Item Name: Crosstube Turning Detail

DART AEROSPACE LTD	Work Order:	179208
Description: Crosstube Assembly	Part Number:	D407-667-145
Inspection Dwg: D407-667-145 Rev: C		Page 1 of 1

DRAWING NO. D407-667-145	TITLE CROSSTUBE ASS'Y (407 HIGH FWD)	REV. C	DART AEROSPACE LTD ENGINEERING ORDER		D.E.O. NO. D407-667-145-C-1	SHEET NO. SHEET 1 OF 1	SCALE NTS
DRAWN QP	CHECKED ASS	MFG. APPR. LB	APPROVED WD		DE APPR. H		
DATE 11.07.15	DATE 11.07.22	DATE 11.07.22	DATE 11/07/22		DATE 11.07.21

DRAWING NO. D407-667-145	TITLE CROSSTUBE ASS'Y (407 HIGH FWD)	REV. C	DART AEROSPACE LTD ENGINEERING ORDER		D.E.O. NO. D407-667-145-C-2	SHEET NO. SHEET 1 OF 1	SCALE NTS
DRAWN AJS	CHECKED	MFG. APPR. <i>E</i>	APPROVED <i>AP</i>		DE APPR. <i>[Signature]</i>		
DATE 12.08.02	DATE 12.08.02	DATE 12.08.02	DATE 12.08.02		DATE 12.08.02

DETAIL P
BONDING STRAP INSTALLATION 2 PL

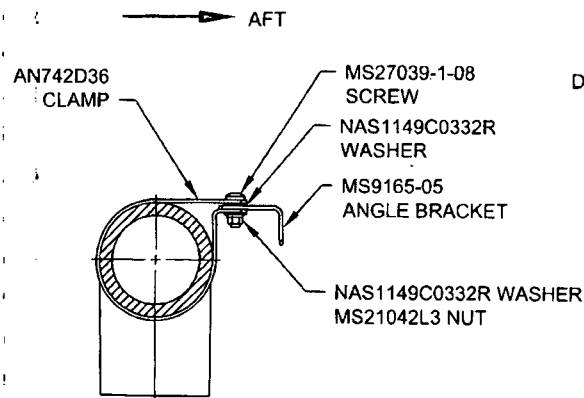
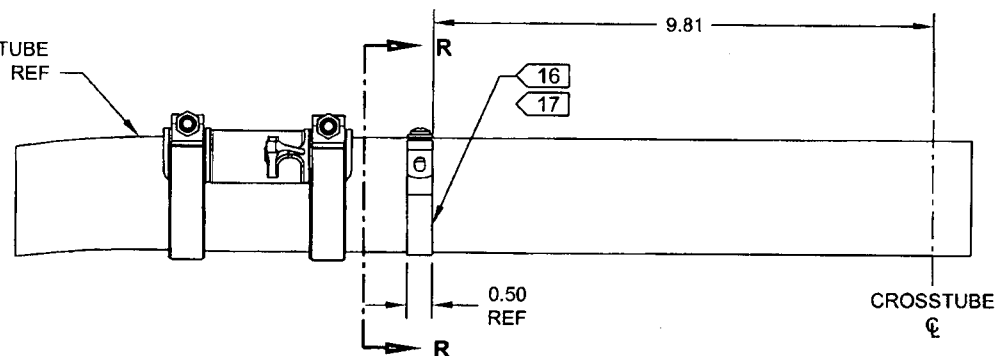
ADD ELECTRICAL GROUNDING STRAP

ITEM	QTY -145	PART NUMBER	DESCRIPTION
1	X	D407-667-145	CROSSTUBE ASSEMBLY (407 HIGH FWD)
10	2	AN742D36	CLAMP
11	2	MS9165-05	ANGLE BRACKET
12	2	MS21042L3	NUT (OR MS21042-3)
13	2	MS27039-1-08	SCREW
14	4	NAS1149C0332R	WASHER (OR AN960C10L)

- 16) MASK AREA UNDER CLAMP PRIOR TO PAINTING
 - 17) SEAL EDGES WHERE AN742D36 CLAMP MEETS WITH THE CROSSTUBE USING SIKAFLEX-241/-291 OR MIL-S-8802 CLASS B2 OR PROSEAL 890 SEALANT
 - 18) PERFORM RESISTANCE CHECK TO ENSURE MAX RESISTANCE IS 10 MILLIOHMS
- } ADD
